Block(s): 16 & 17 Section: 13 District/Division: MAWSON

Issue	Date	Amendment
Project		
Multi Unit Housing		
Site		
blocks 16+17		
section 13,		
Mawson, ACT.		
Title		
Site Plan		
Scale	1:200	Drawn By SA
Date	May 2008	Drawing No. 1284 - A
PETER BYFIELD + Associates Suits A, 34 Taylor Street, Ainsworth NSW 2158 Phone 02 9880 2255 Fax 02 9660 2255

Title
**Neighbour Notification Plan
Units 1-5**

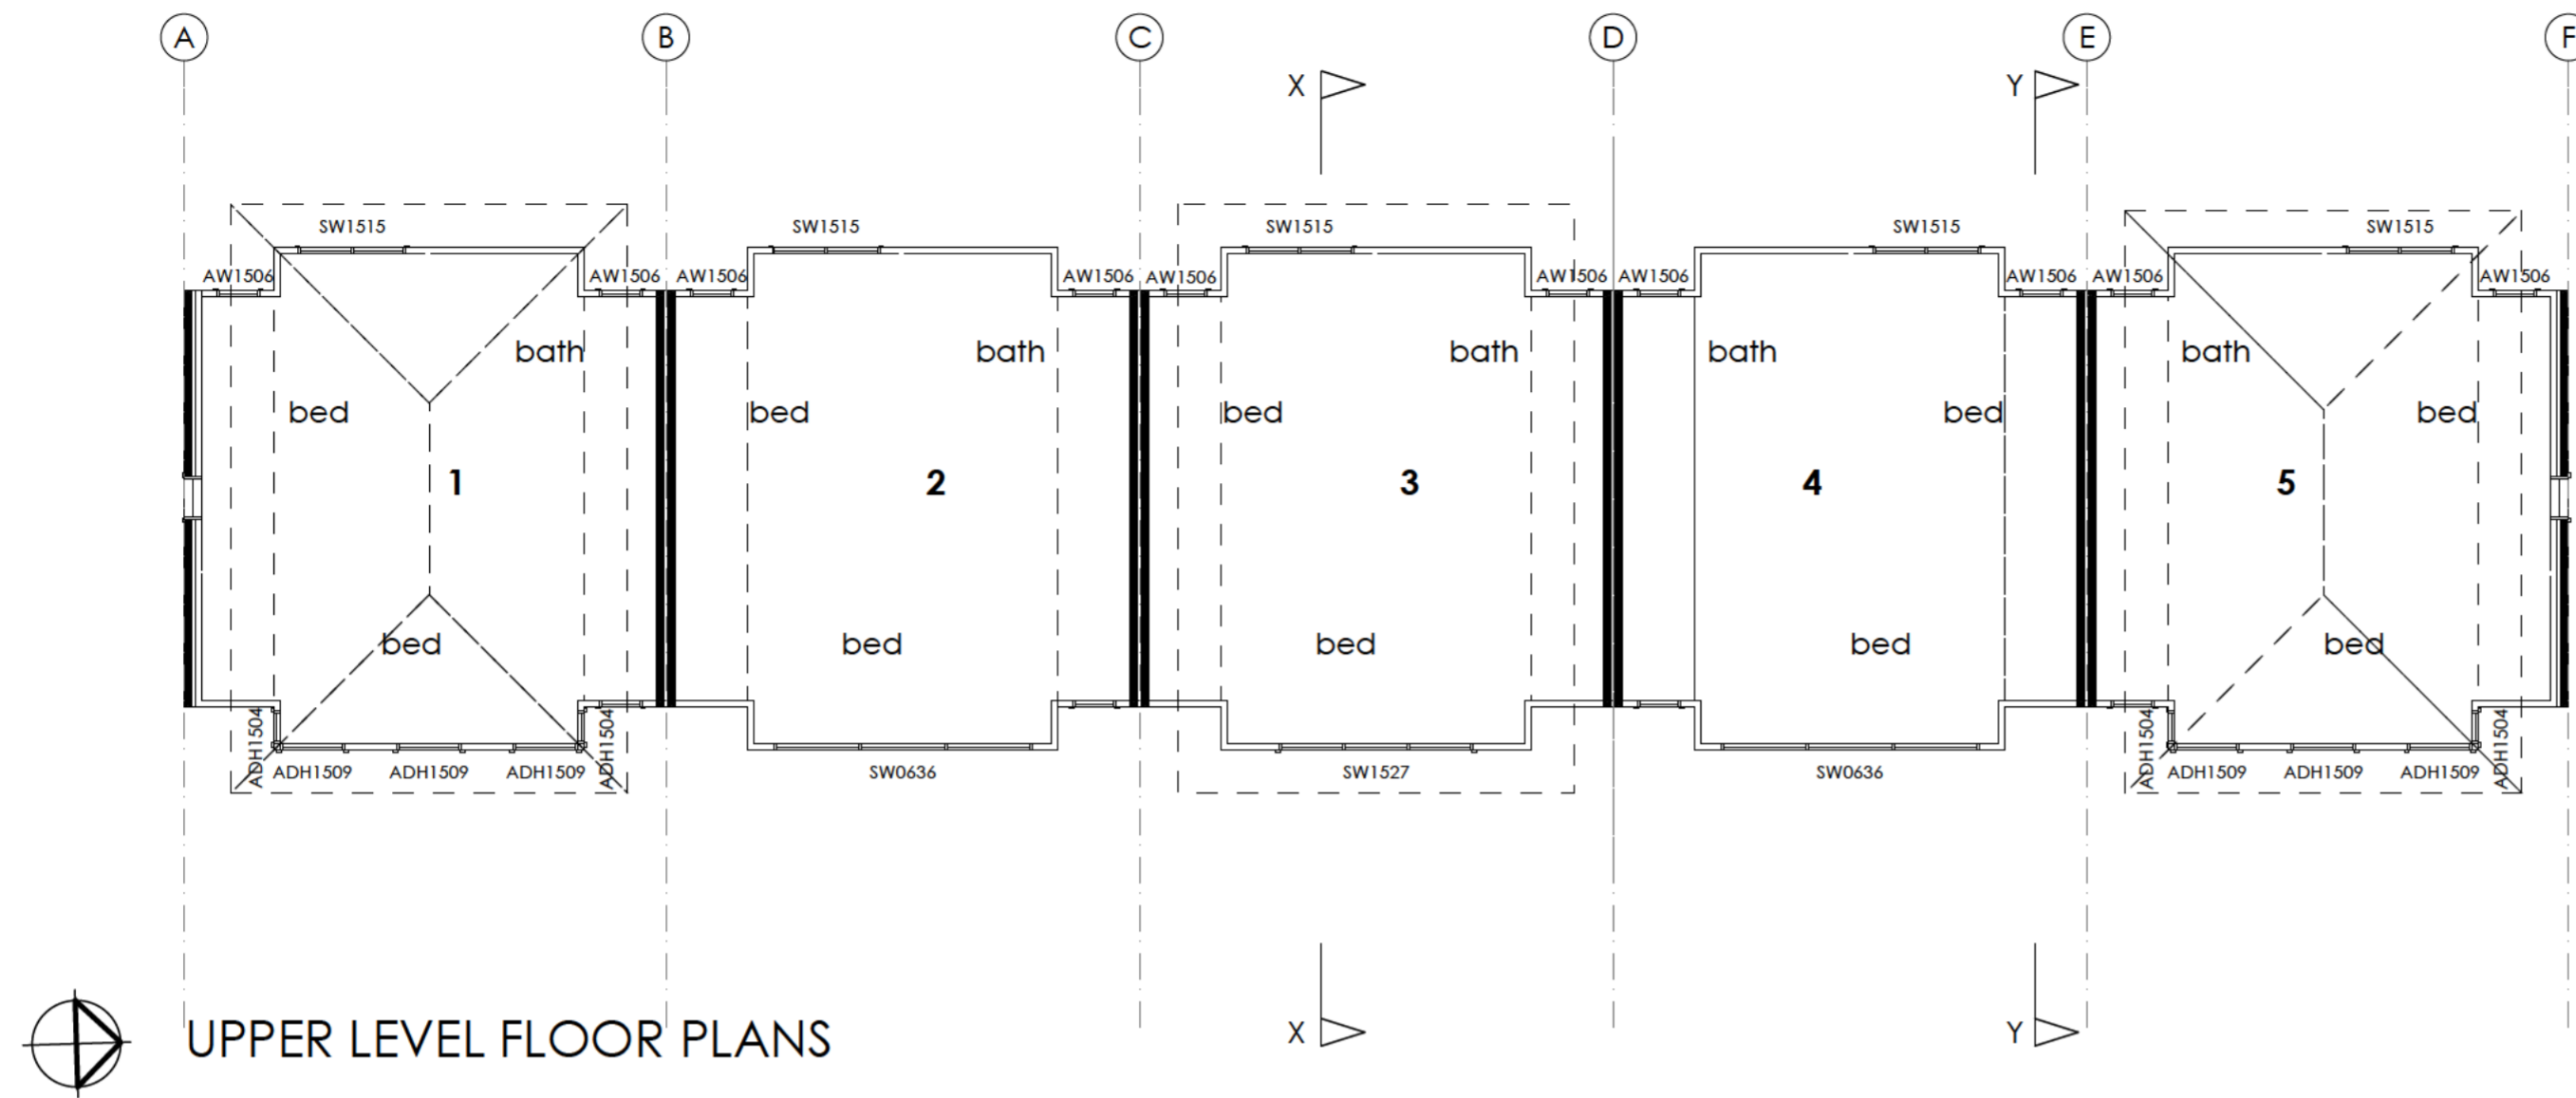
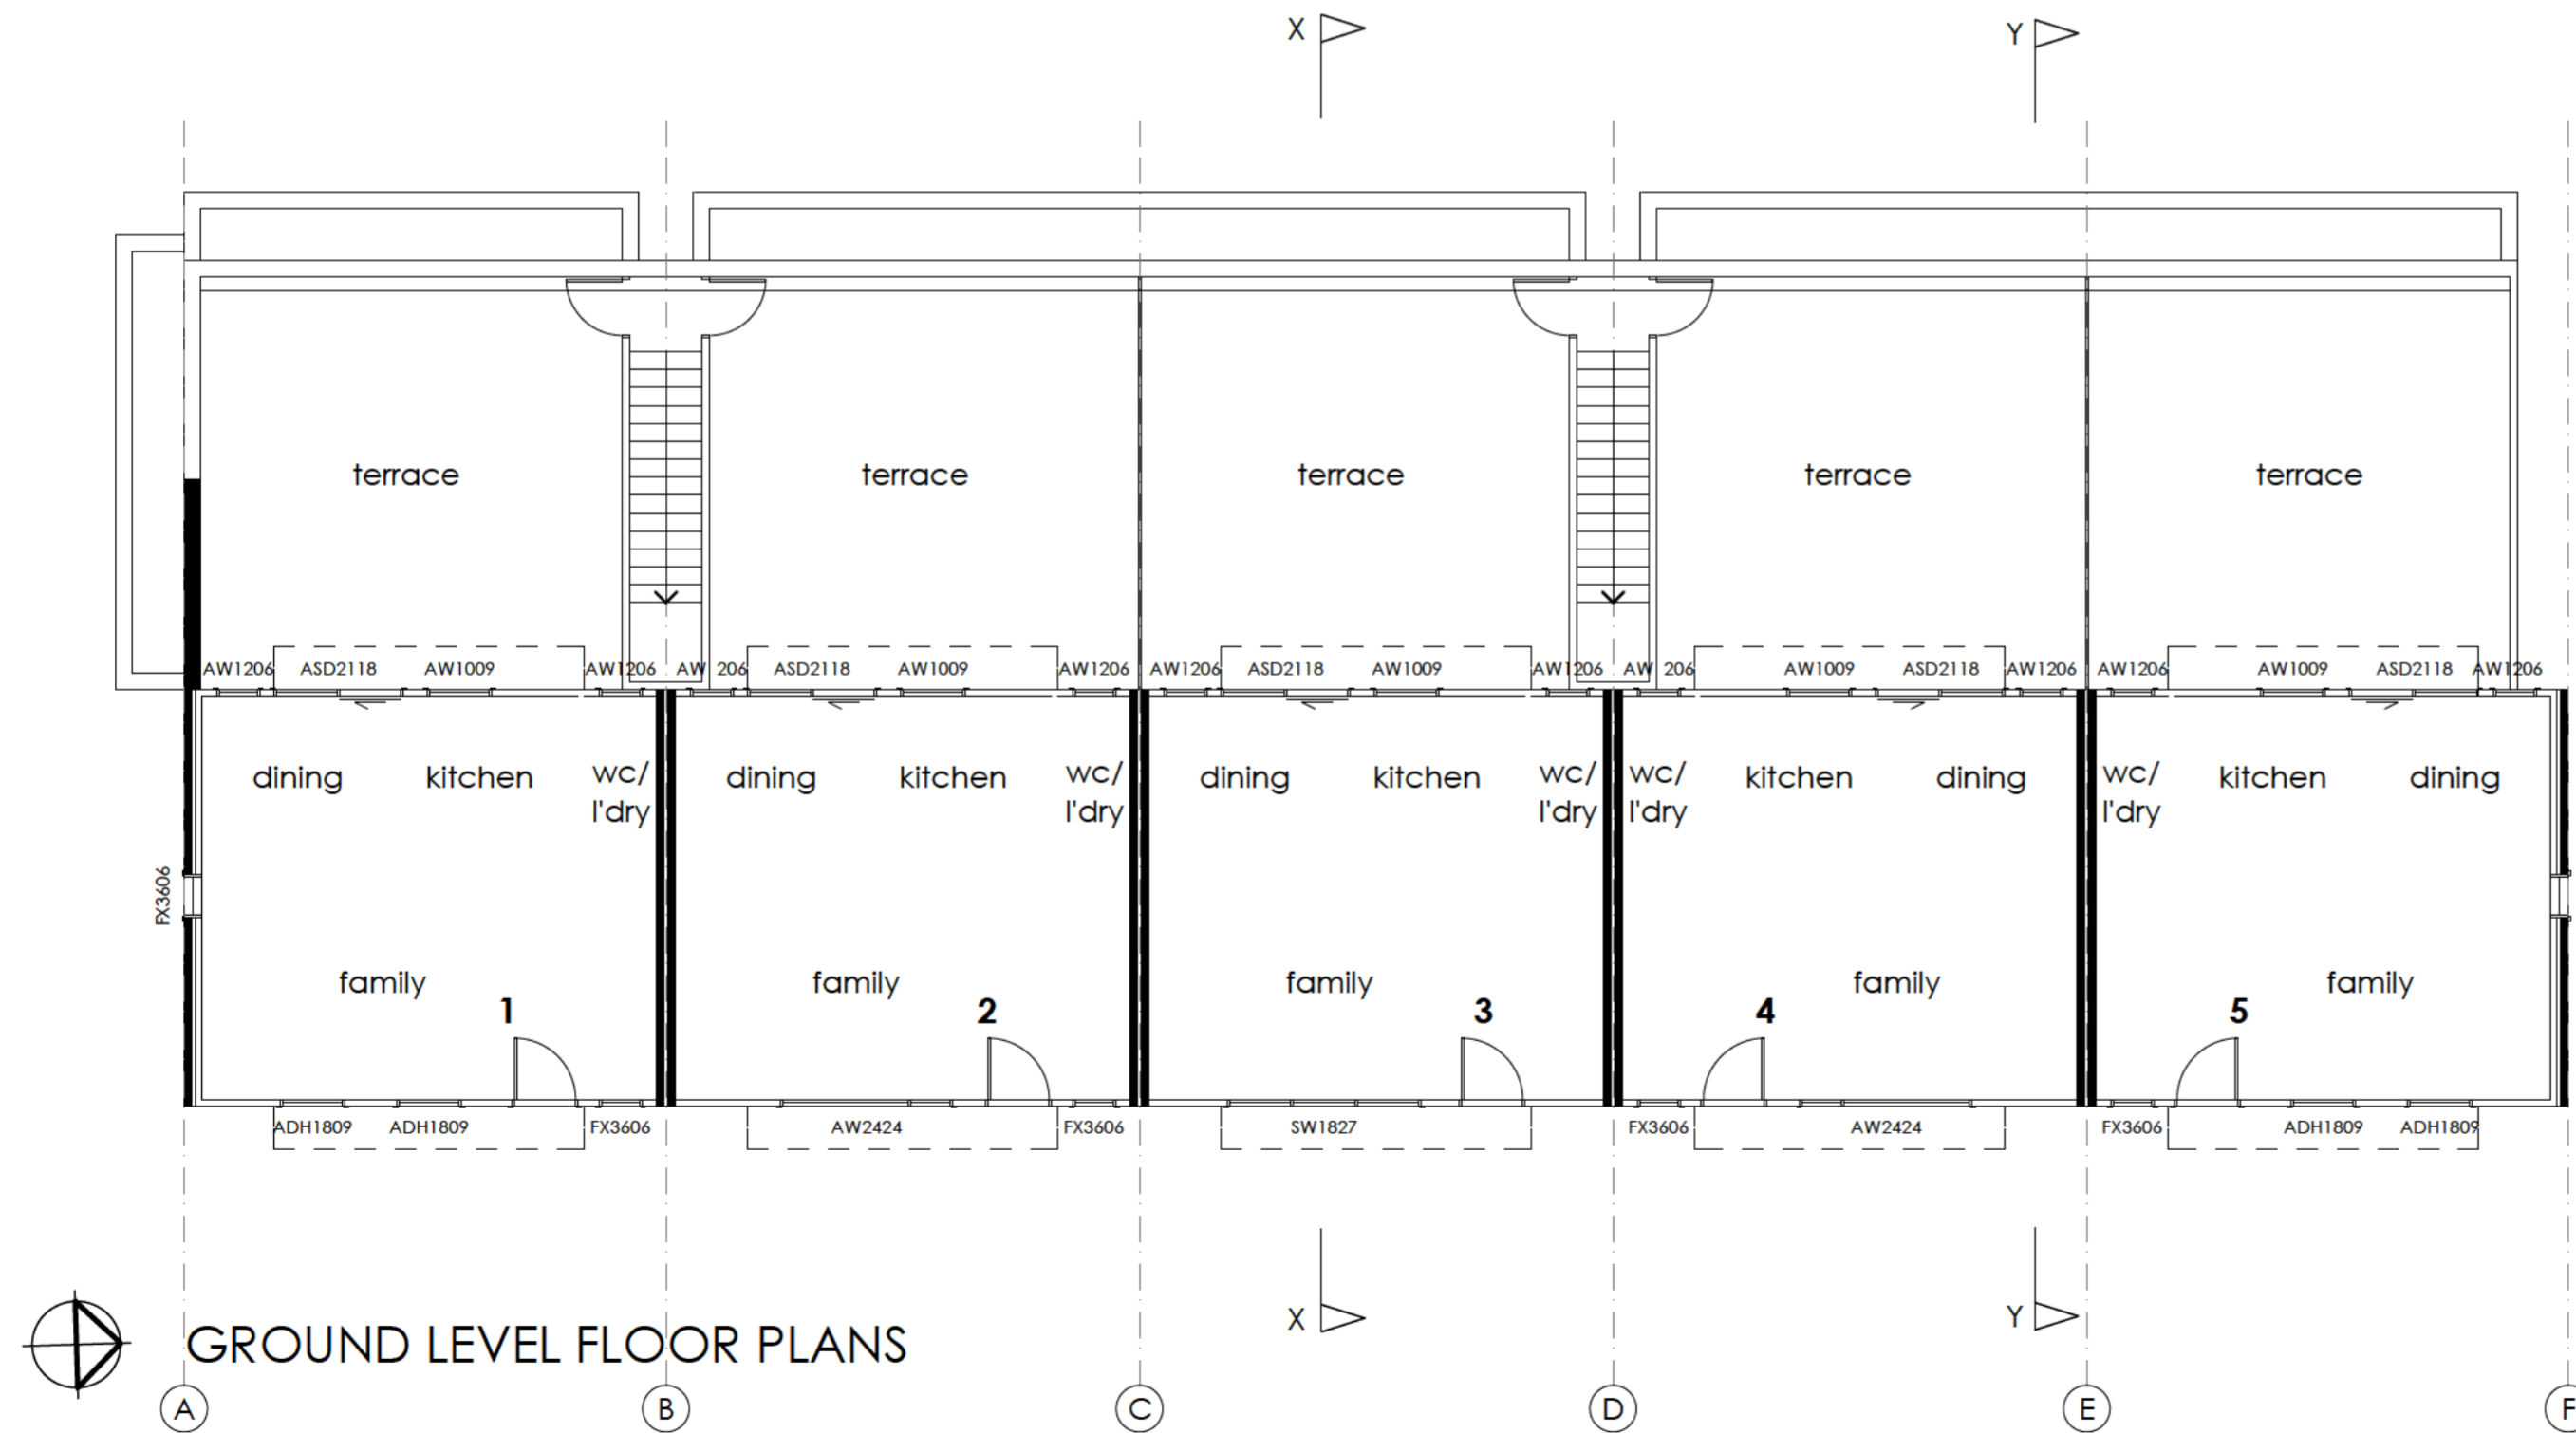
6. Provide enclosure for units 6-9 waste bins.
- | Issue | Date | Event |

Title
**Neighbour Notification Plan
Units 6-10**

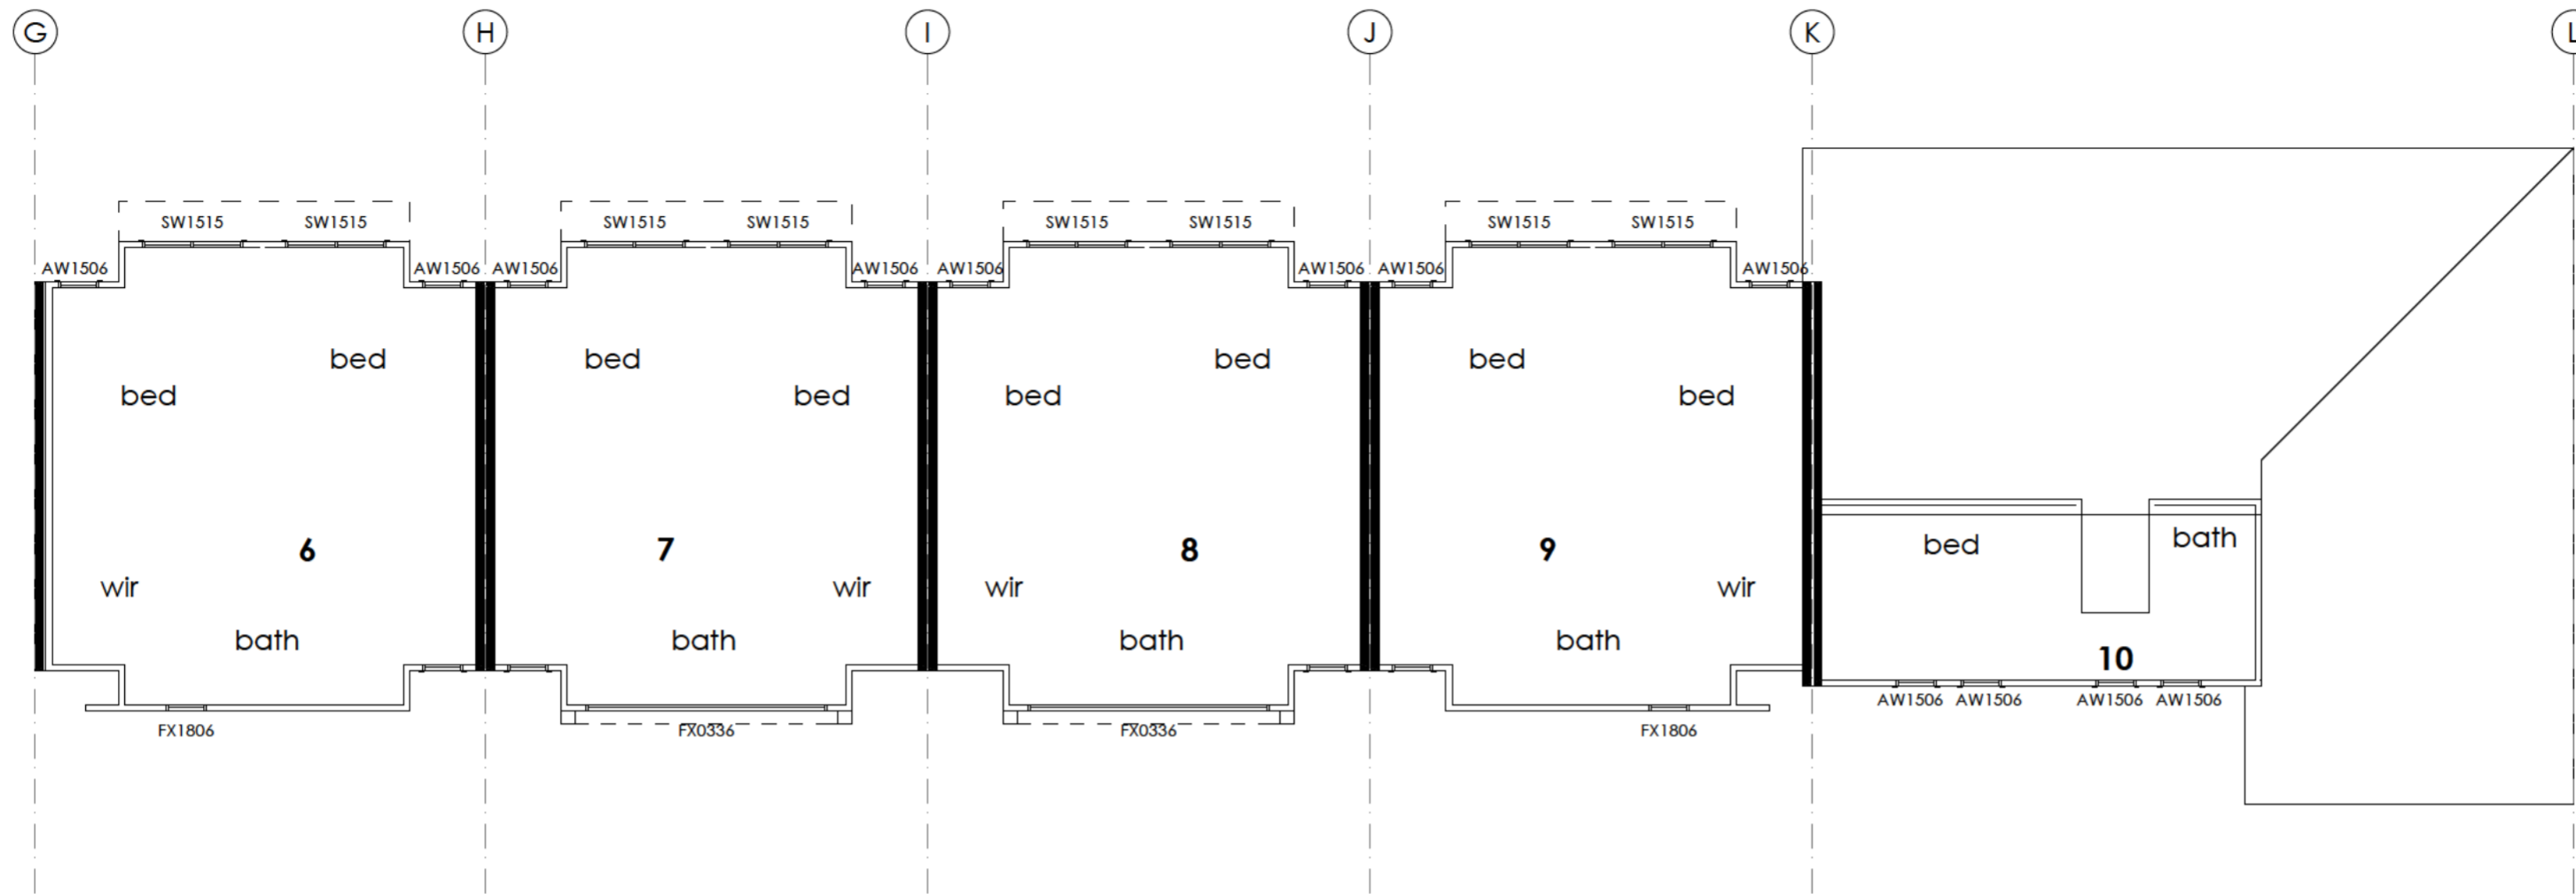
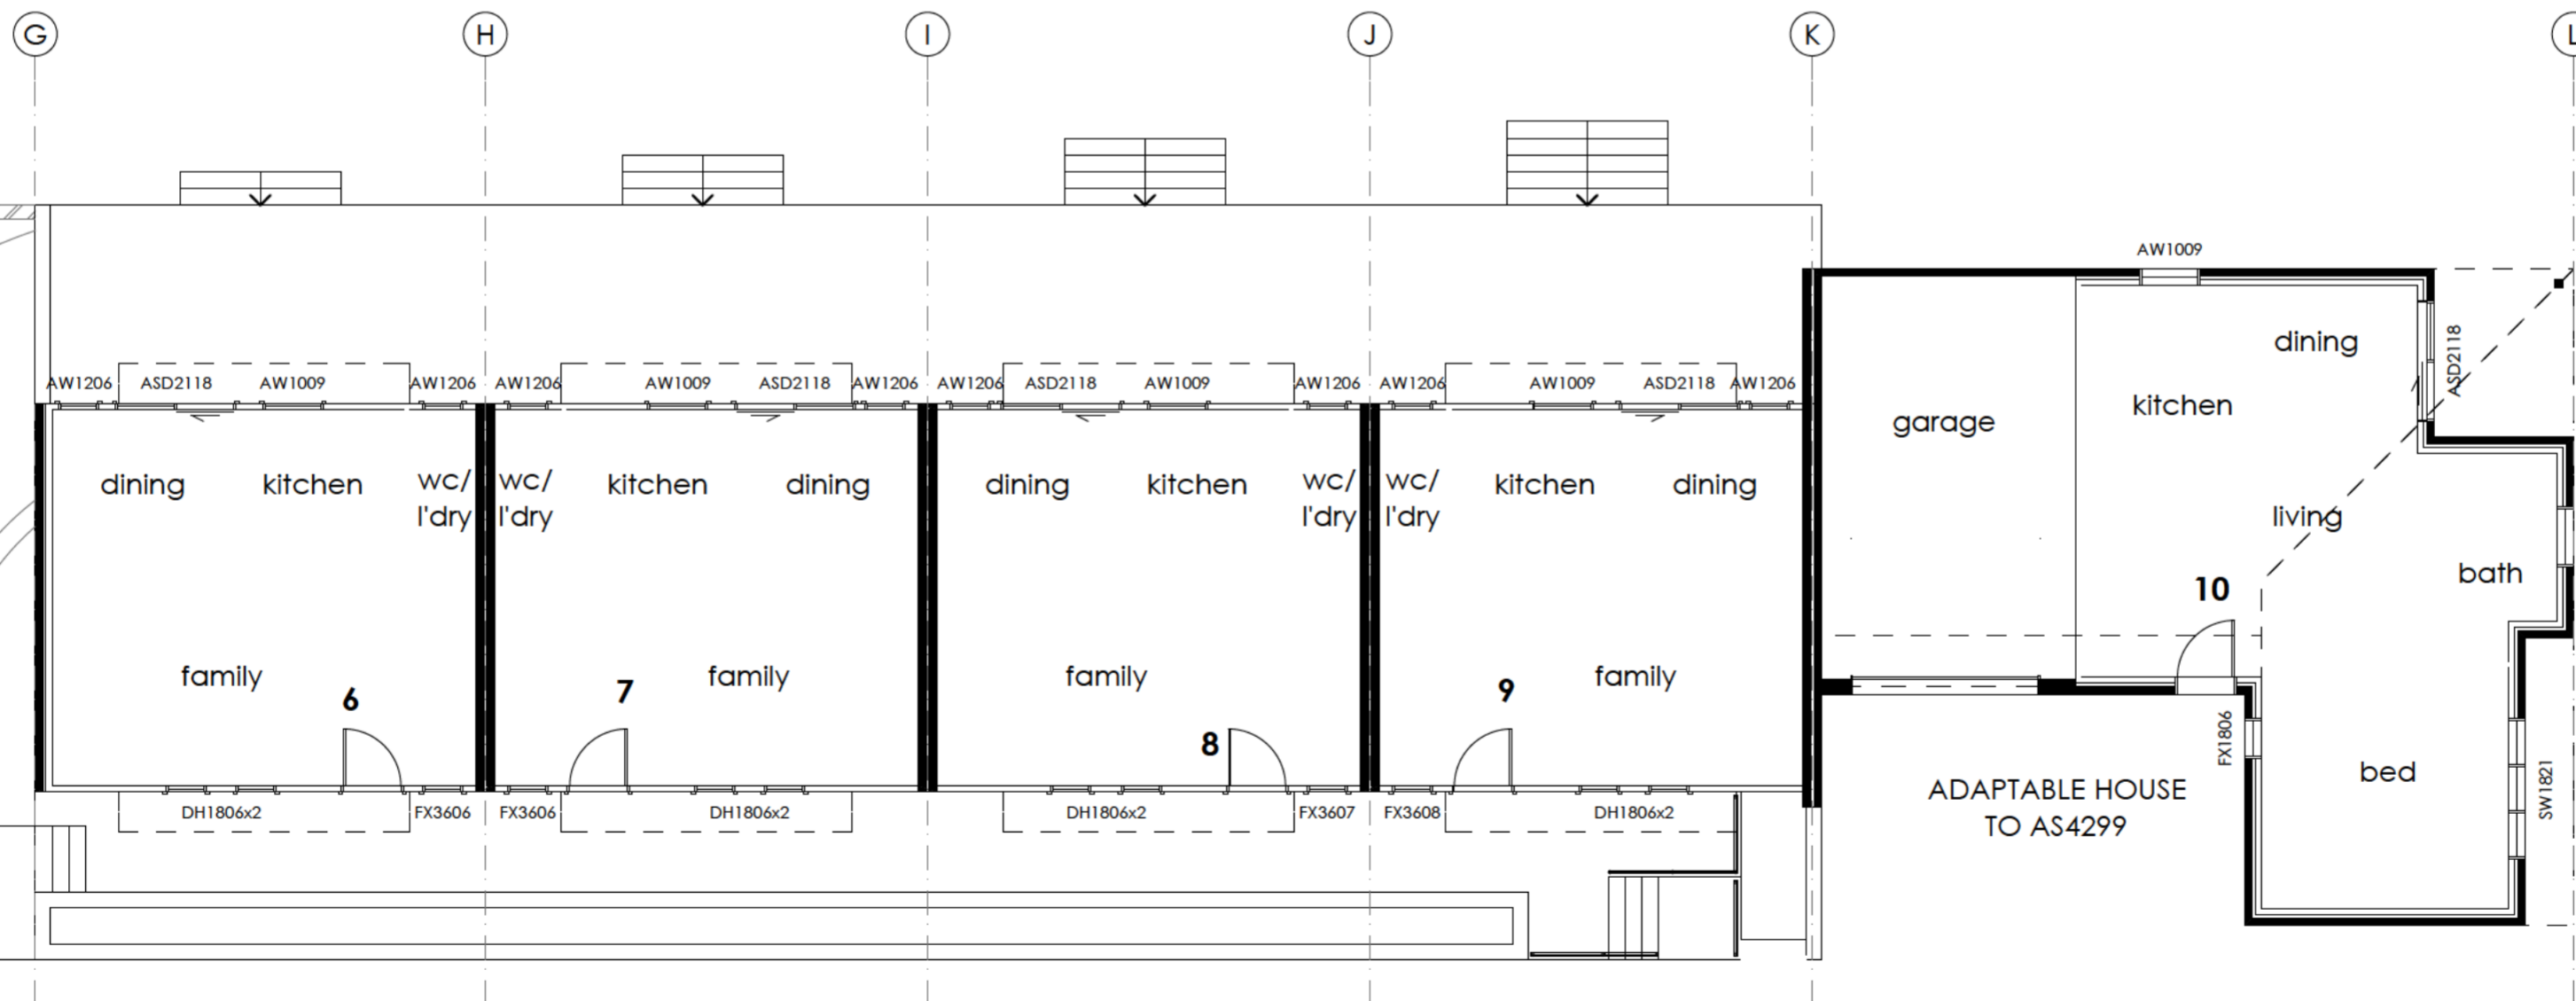
1. Increase floor levels of units 6-9 by 700mm.
2. Create basement parking under units 6-9 (9 spaces) accessed via a vehicular ramp.
3. Relocated unit 10 to achieve a rear setback of 4m.
4. Convert car parking under units 1-5 to allow for 2 car spaces per unit (1-5).
5. Relocated 3 visitor car spaces.
6. Provide enclosure for units 6-9 waste bins.
